AFRICATOWN HERITAGE HOUSE SUBDIVISION

Engineering Comments: FINAL PLAT COMMENTS (should be addressed prior to submitting the FINAL PLAT for review and/or signature by the City Engineer):

Revised for the December 2nd meeting:

DETAIL SITE PLAN

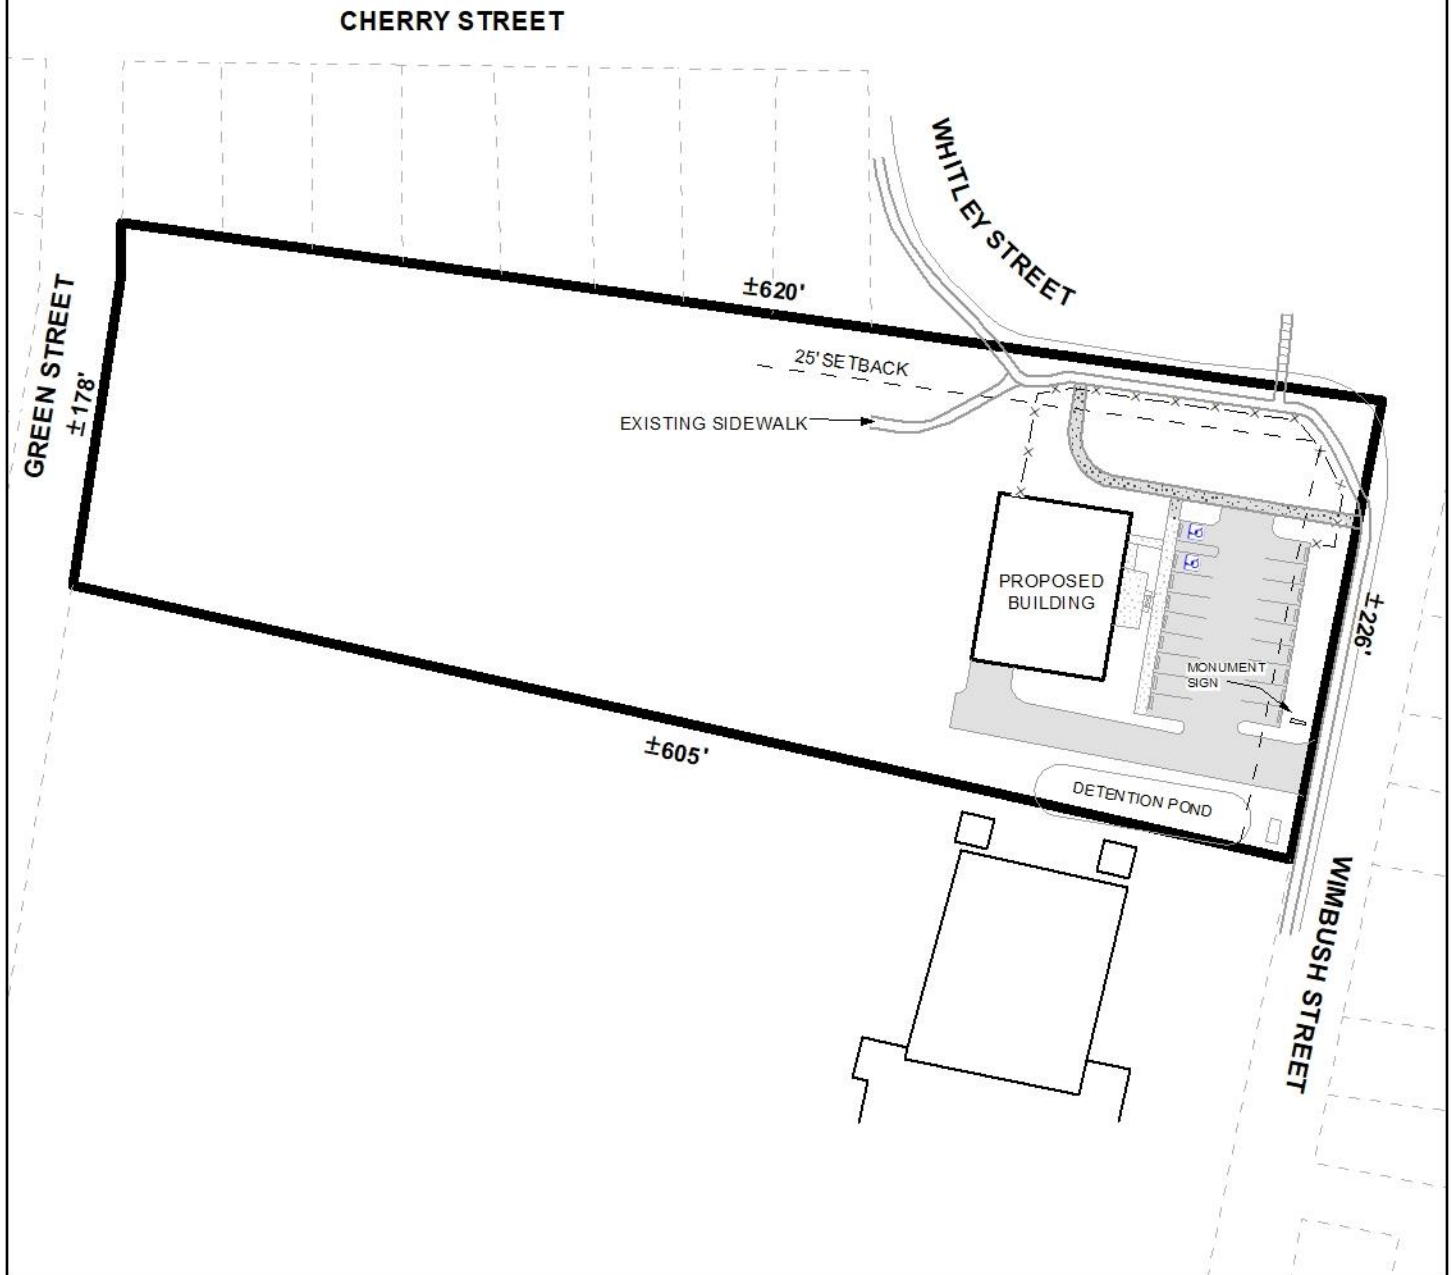
The proposed lot fronts Whitely Street and Wimbush Street, both all minor streets without curb and gutter. The preliminary plat does not illustrate the existing rights of way along these streets; therefore, the provision of adequate right-of-way to provide 30-feet from the centerline of Whitely Street and Wimbush Street should be shown on the Final Plat. The site also fronts Green Street, a minor street with curb and gutter, which should have a 50-foot right-of-way. If approved, dedication to provide 25-feet from the centerline of Green Street should be required, if necessary. Additionally, the provision of a 25-foot minimum building setback line should be illustrated from any required dedication. Furthermore, as the site is located at the corner of Whitely Street and Wimbush Street, the dedication of a corner radius should be required, if approved.

- 1) dedication to provide 30 feet from the centerline of Whitely Street and Wimbush Street;
- 2) dedication to provide 25 feet from the centerline of Green Street;
- 3) dedication to provide a 25-foot radius curve at the intersection of Whitely Street and Wimbush Street;
- 4) illustration of the 25-foot minimum building setback line on the Final Plat as measured from any required dedication along all rights-of-way;

- 5) retention of the lot size labels on the Final Plat, adjusted for any required dedication, or the furnishing of a table on the Final Plat providing the same information;

- 6) placement of a note on the Final Plat stating that no structure may be constructed or placed within any easement without the permission of the easement holder;
